**PRODUCT BULLETIN # 16817**

**TITLE:** Packaging Changes Affecting Sanyo Thailand Impacted Products

**AFFECTED CHANGE CATEGORY(S):** Packaging Changes

### Graphical Shipping Package Variations for Future Shipments

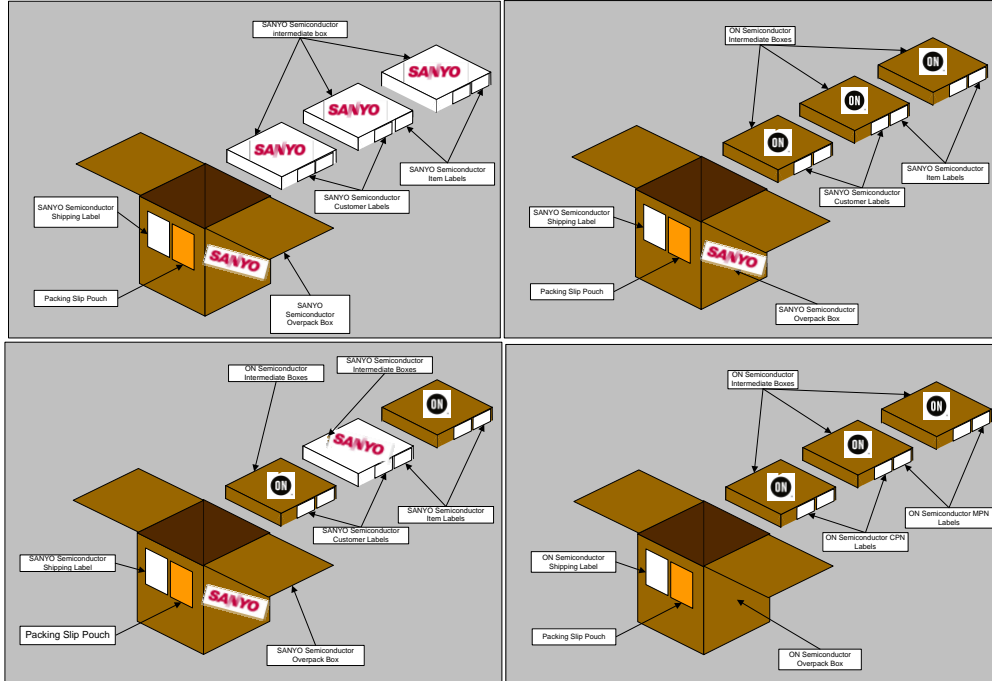
The severe floods in Thailand have caused ON Semiconductor to perform manufacturing transfers in order to support pre-flood production. Please note the Shipping Package guidelines and changes indicated by assembly package group. The changes are only for products affected by SSTH recovery and are not for all ON Semiconductor or SANYO Semiconductor products.

<b>Over pack Box Logo</b>	SANYO	SANYO	SANYO	None
<b>Over pack Shipping Label</b>	SANYO	SANYO	SANYO	ON
<b>Intermediate Box Logo</b>	SANYO	ON	ON/SANYO	ON
<b>Intermediate Box Label</b>	SANYO Item label/Customer label	SANYO Item label/Customer	SANYO Item label/Customer	ON MPN/CPN
<b>Primary Package Label</b>	SANYO Item label/Customer label	SANYO Item label/Customer	SANYO Item label/Customer	ON MPN/CPN
